UN Regulation No. 16 (Safety-belts)

Proposal for the 09 Series of Amendments to UN Regulation No. 16 (Safety-belts) *

Submitted by the expert from the Netherlands

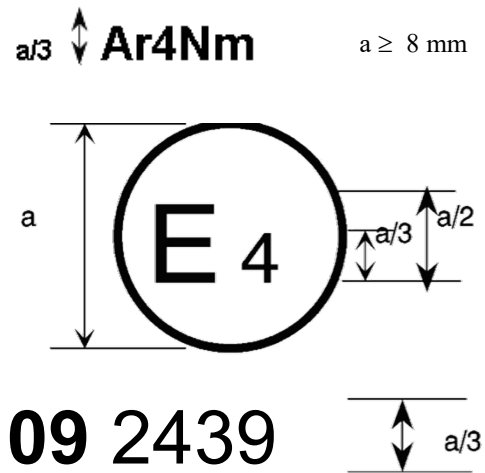
The belt ... 06, 07, ~~08~~ or **09** series of amendments at the time of approval.

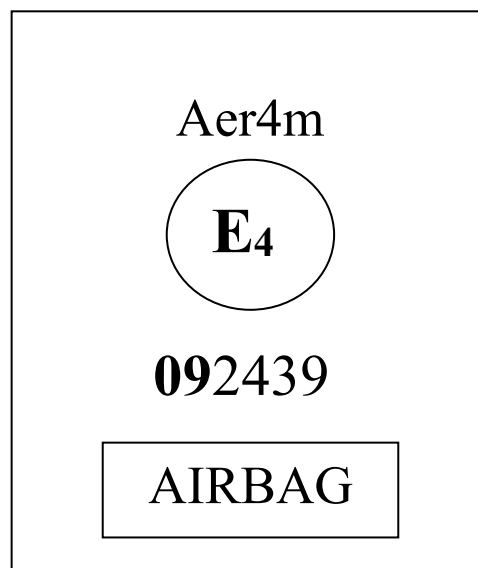
The belt ... the 06, 07, ~~08~~ or **09** series of amendments at the time of approval.
